# Design Review Board Agenda

**CITY OF MILL CREEK  
DESIGN REVIEW BOARD  
APPLICATION PL2016-0001**

**CITY OF MILL CREEK  
DESIGN REVIEW BOARD  
APPLICATION PL2016-0002**

Revised Concept 2

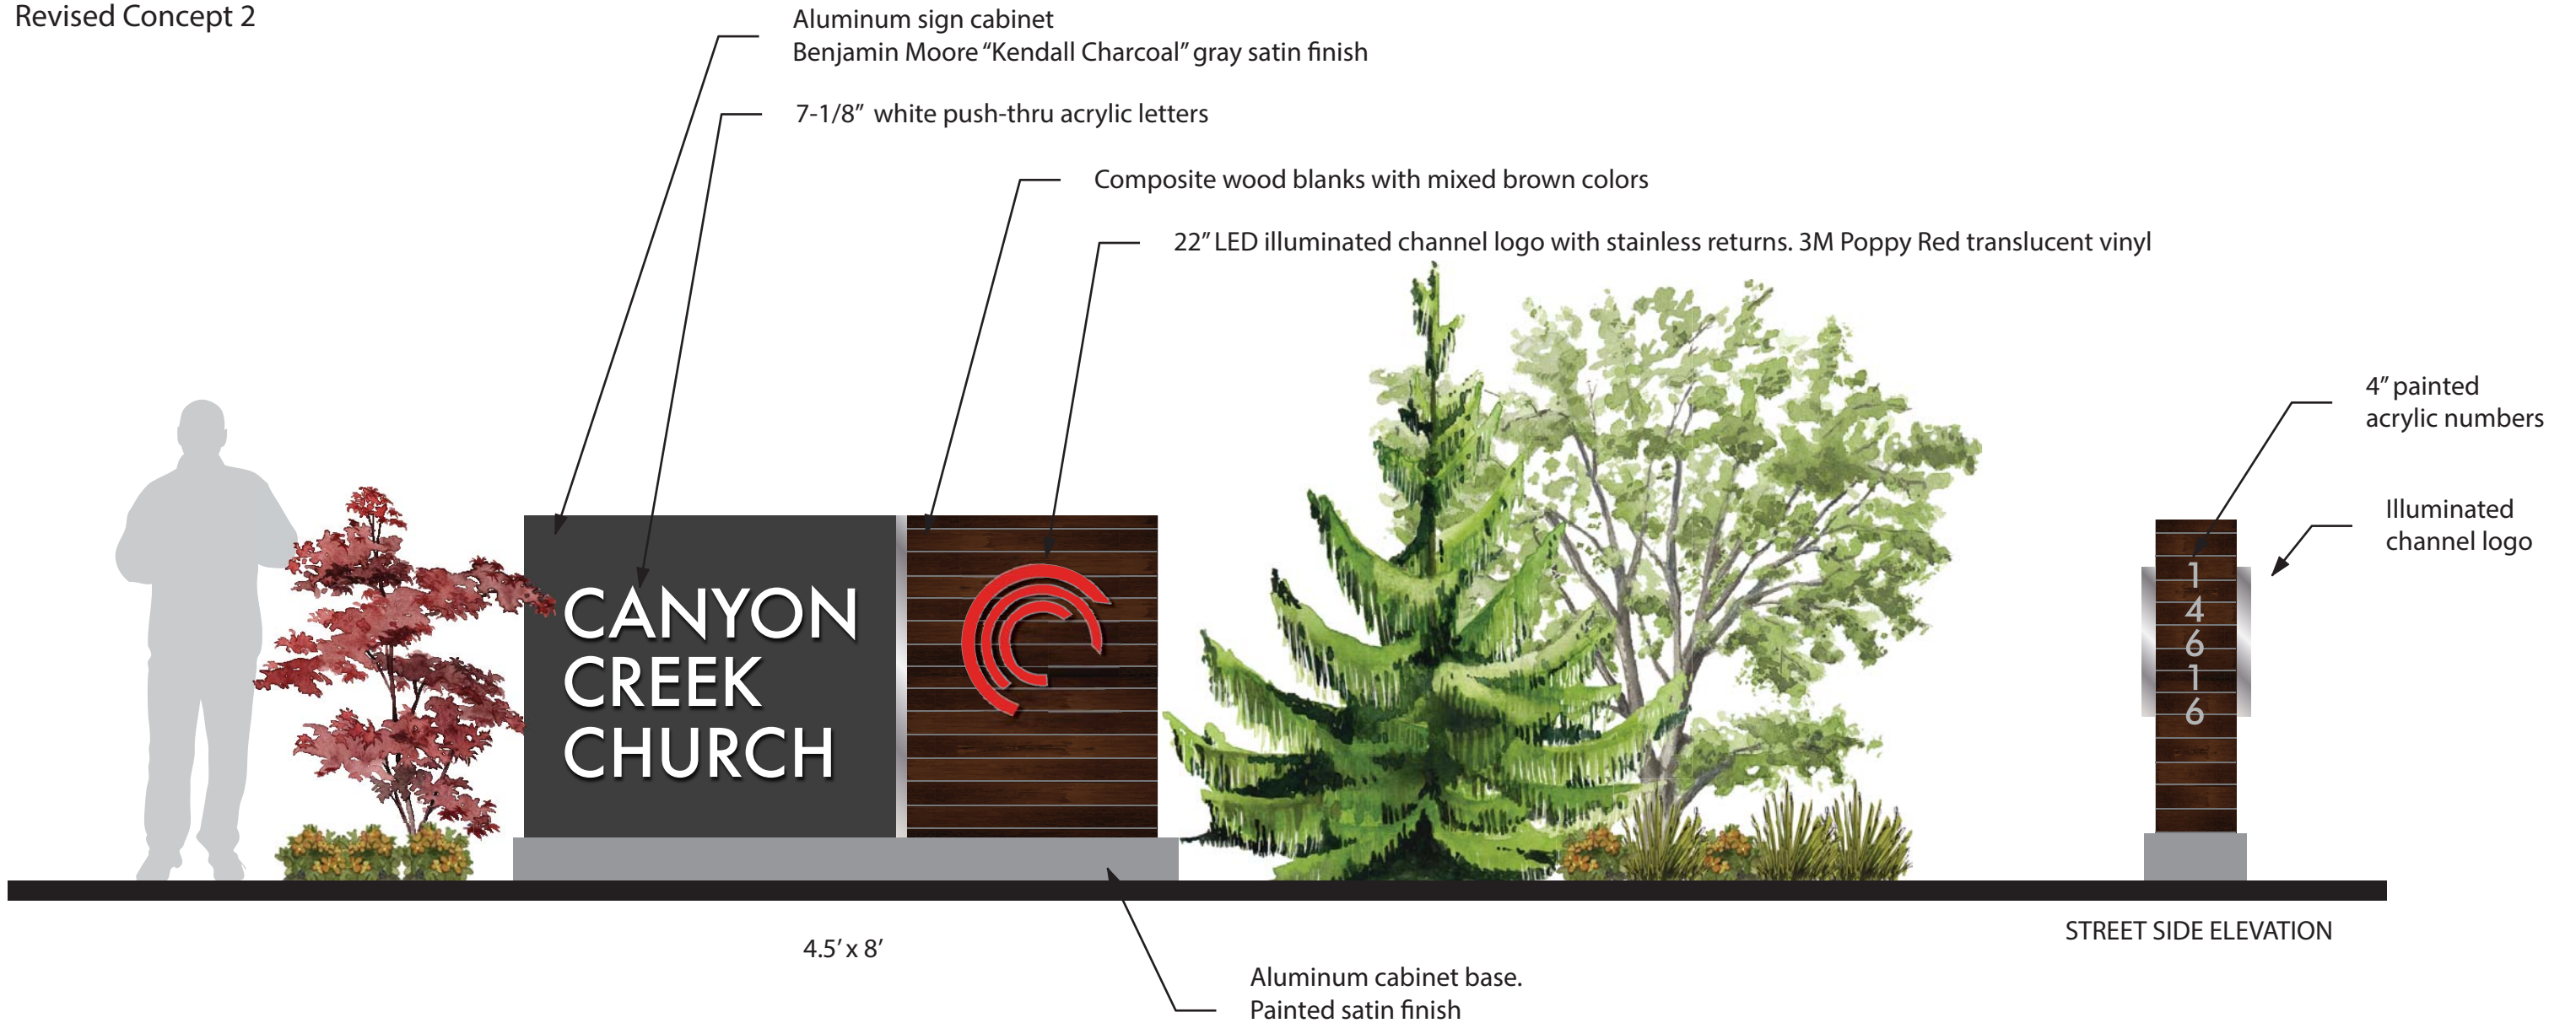
MCMC Section 17.34.040.G requires that freestanding monument signs be designed to be complementary to, and coordinated with, building colors and be in scale and proportion with building design, and further states that the sign should provide only the name and address of the building, building complex and/or building tenants. Please see the Sign Plans for sign location, bulk dimensions and colors and materials. As proposed the sign is consistent with the design criteria.

Landscaping is not currently proposed for the landscape bed at the base of the sign; therefore, staff is recommending a Condition of Approval requiring the applicant to plant seasonal annuals and/or low growing shrubs and groundcover at the base of the monument sign.

1. The sign design, materials, and colors shall be as portrayed on the materials submitted with the application, except as may be modified by the conditions imposed by the Design Review Board.
2. The sign shall not be installed until a sign permit is issued by the Building Official.
3. Seasonal annuals and/or low growing shrubs and groundcover shall be planted at the base of the monument sign.

**LANDSCAPE PLAN**

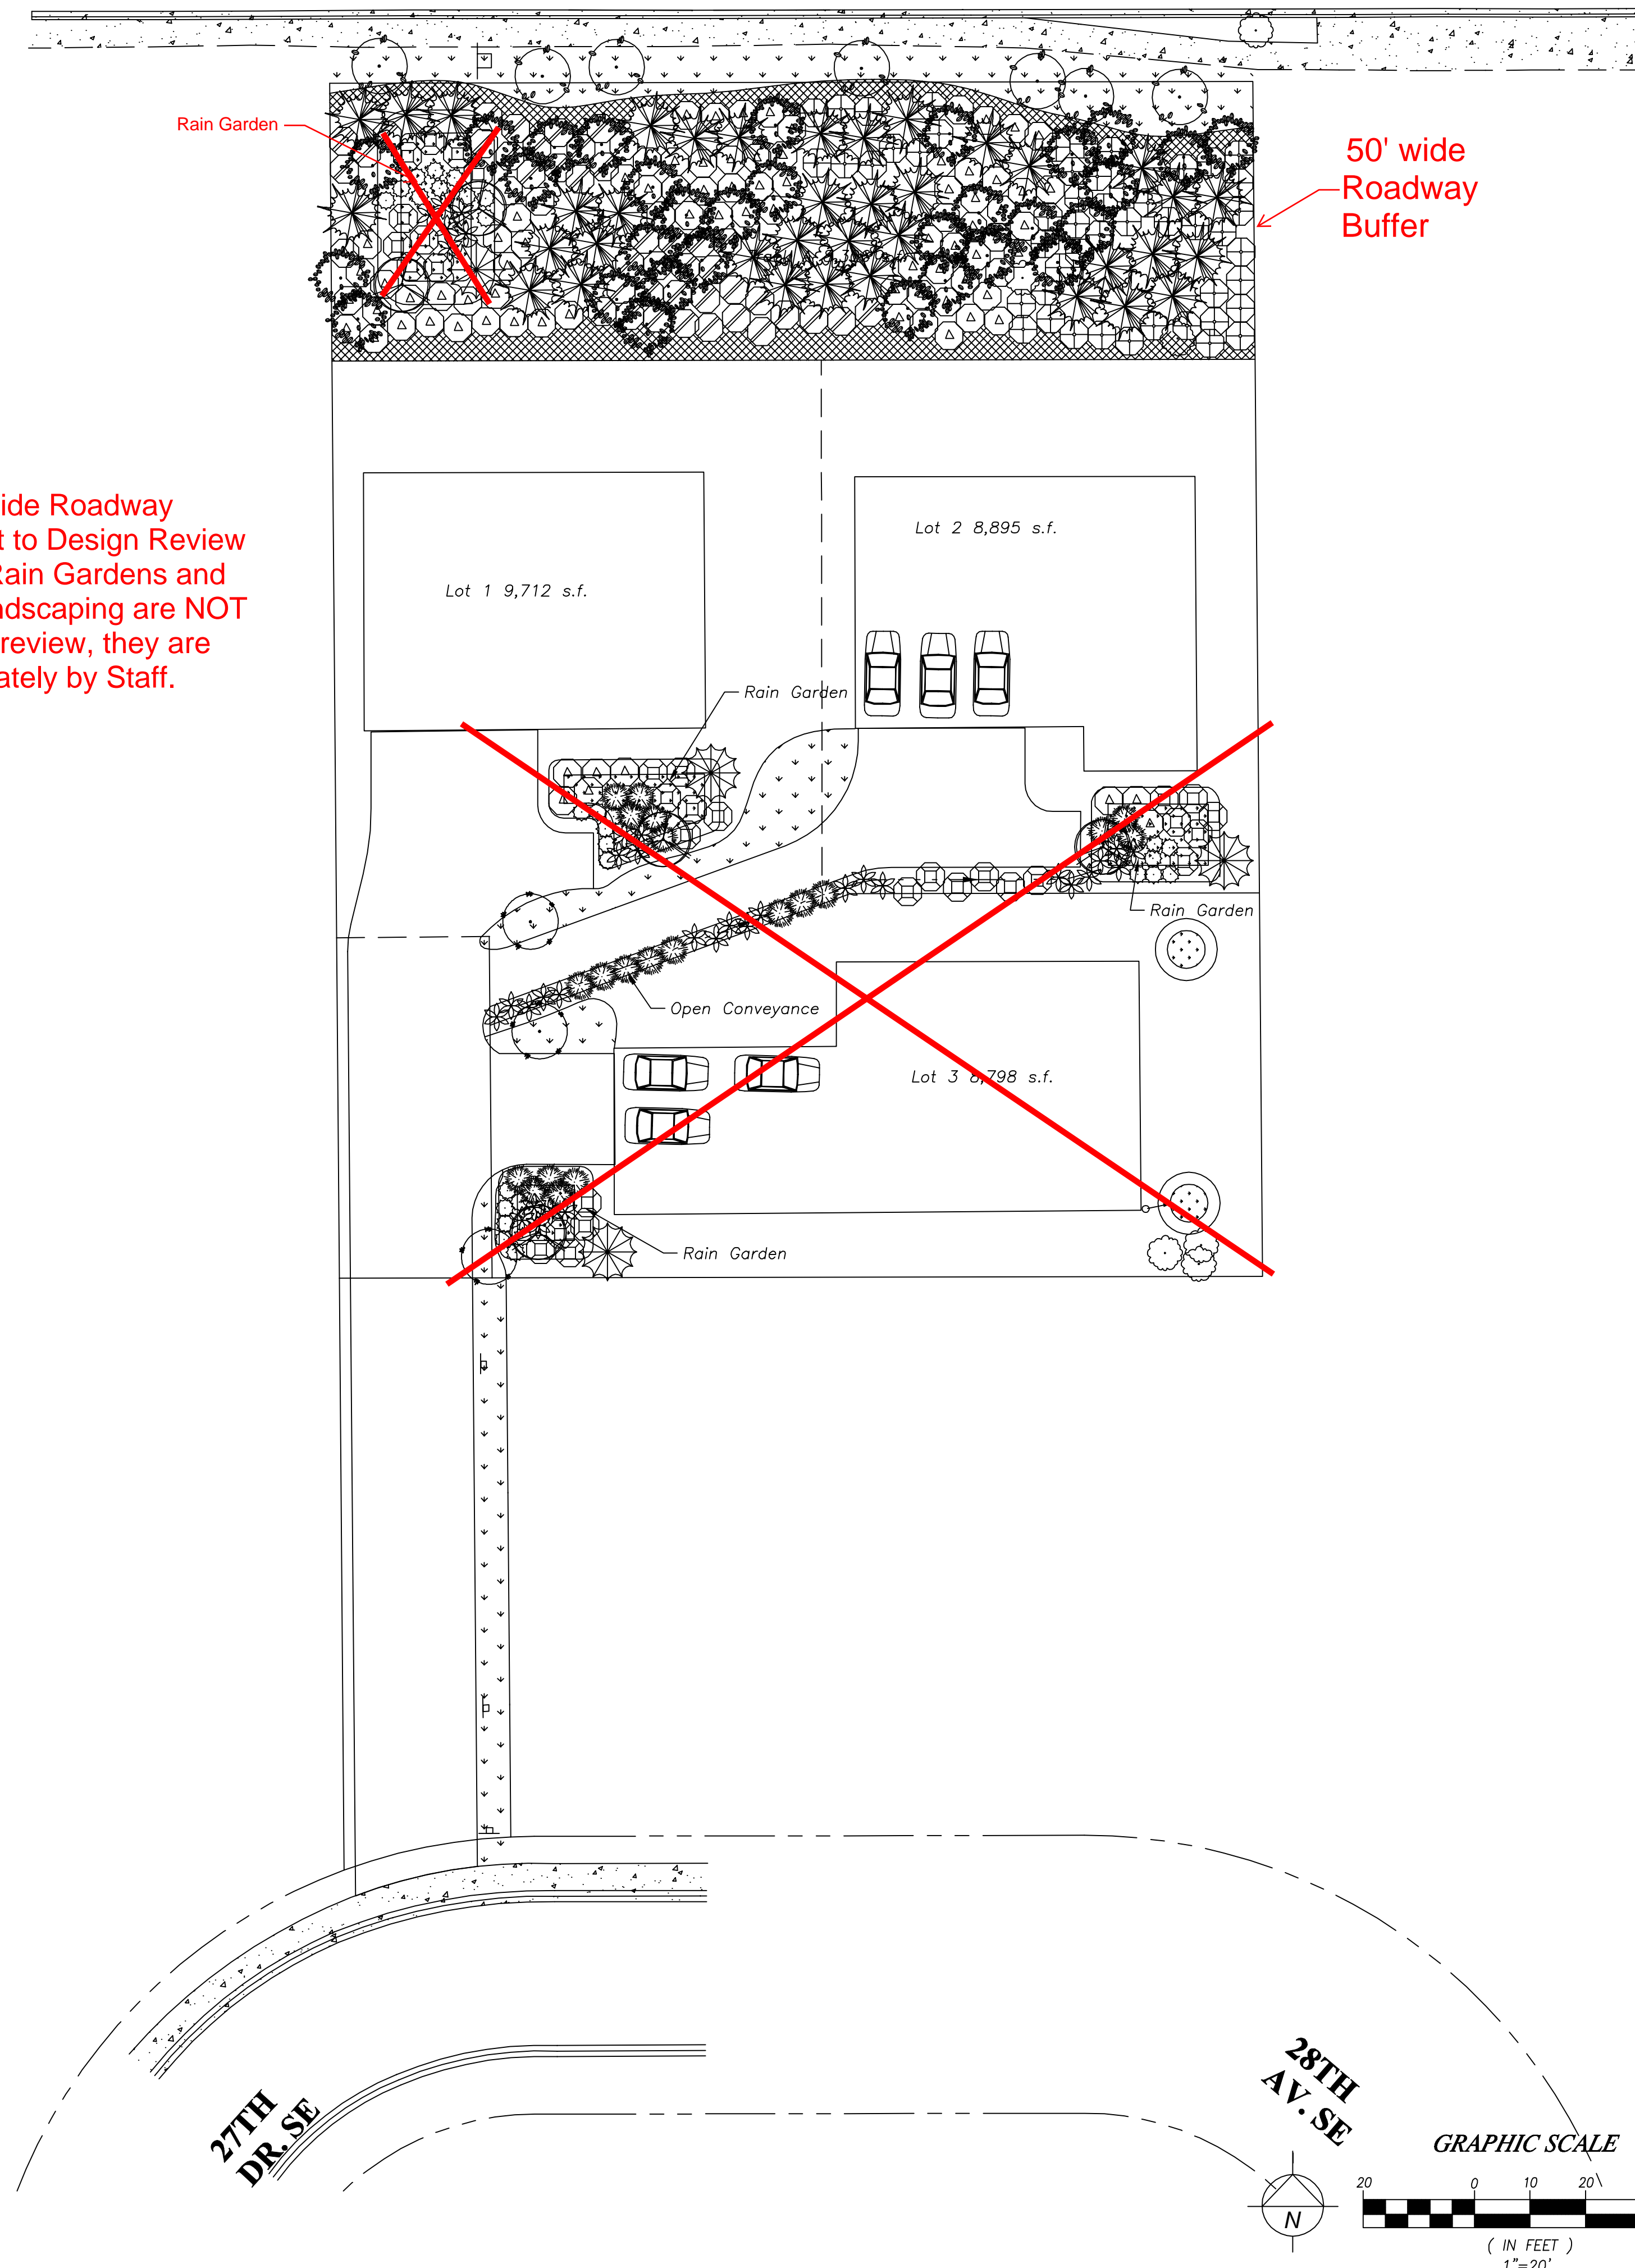
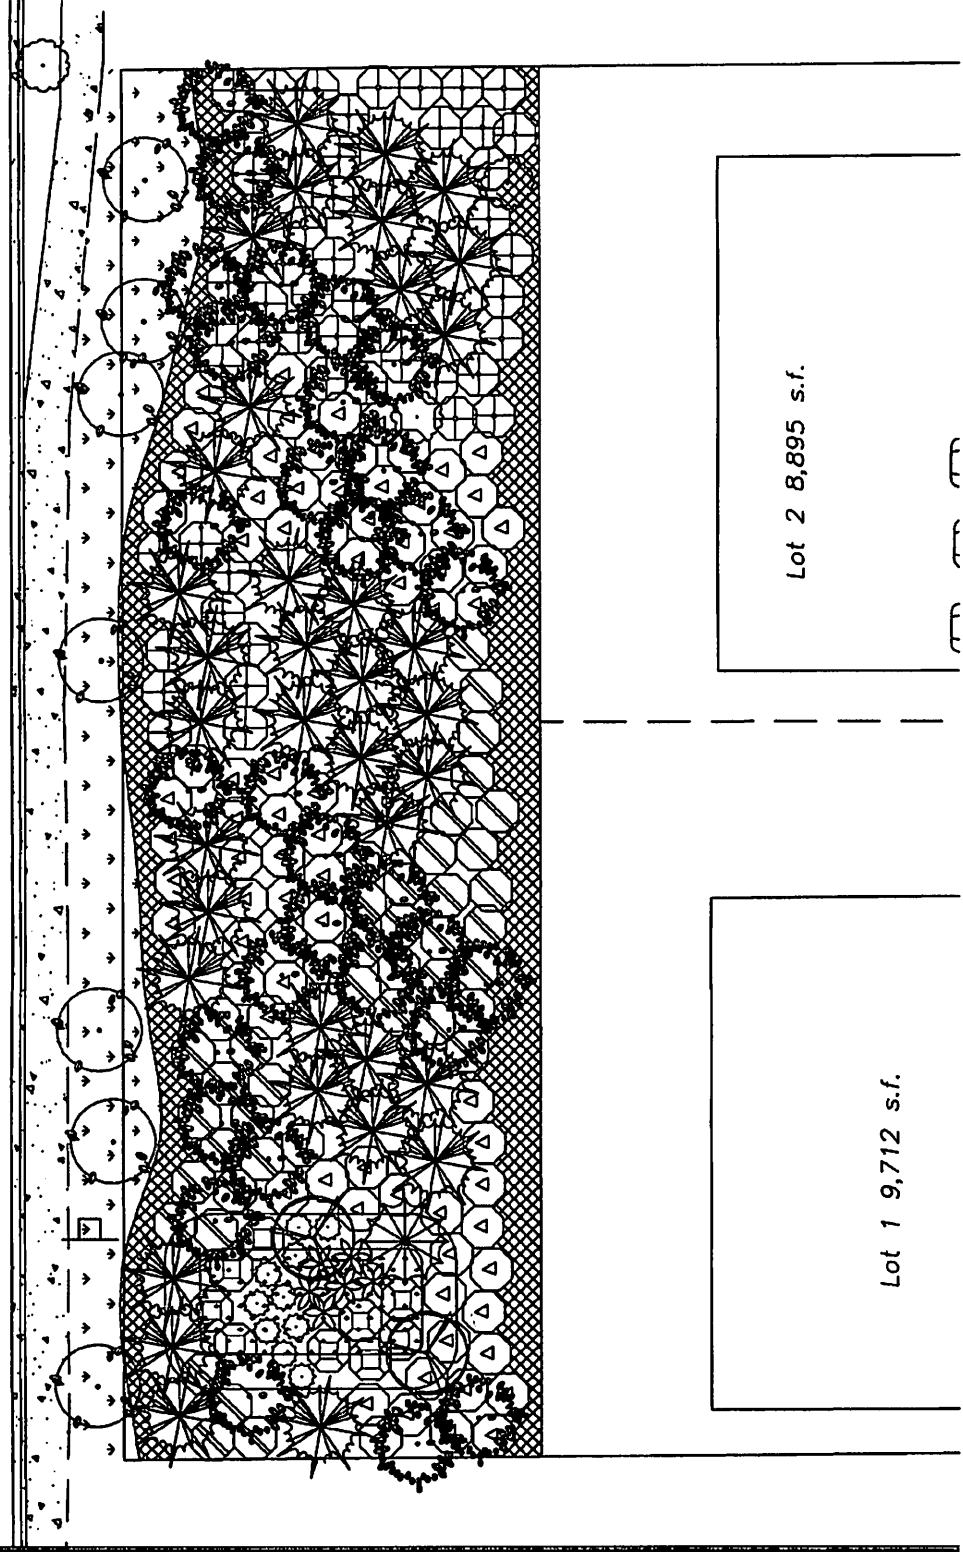
For the required 50-foot wide roadway buffer along 132<sup>nd</sup> Street SE, the existing trees will be preserved as indicated on *Sheet 2 of 3* and will be supplemented with trees and plantings as indicated on *Sheet L-1*.

As conditioned, the landscape plan is in compliance with the design criteria; however, staff does have one recommendation. Raywood ash is proposed as the street tree along 132<sup>nd</sup> Street SE adjacent to the sidewalk. The City has had recent experience with the Raywood ash being susceptible to disease and the Raywood ash has recently been removed from the City's Approved Street Tree list. Therefore, staff is suggesting the selection of another species of tree for this area. In addition, the applicant should consider the mature height (recommending 20 to 25 feet at a maximum) and placement of the selected tree in respect to the existing overhead power lines along 132<sup>nd</sup> Street SE to avoid conflicts and the need for excessive pruning that could affect the tree health.

1. The plant materials and design shall be as portrayed in the application.
2. In the roadway buffer underneath the power lines, consider selecting another species of deciduous tree that has a mature height of 20 to 25 feet at a maximum. Also consider changing the placement of the deciduous trees to avoid conflicts with the power lines.
3. A landscape performance bond in the amount of 125 percent of the proposed cost of labor and material, in accordance with MCMC Section 16.16.040, shall be provided to the City prior to the issuance of the first building permit.
4. Irrigation shall be provided for the roadway buffer, per MCMC Section 17.34.040.H.1.d. The irrigation system will require a building permit. The permit is an over-the-counter plumbing permit, no plans required, with an inspection of the system's backflow prevention.
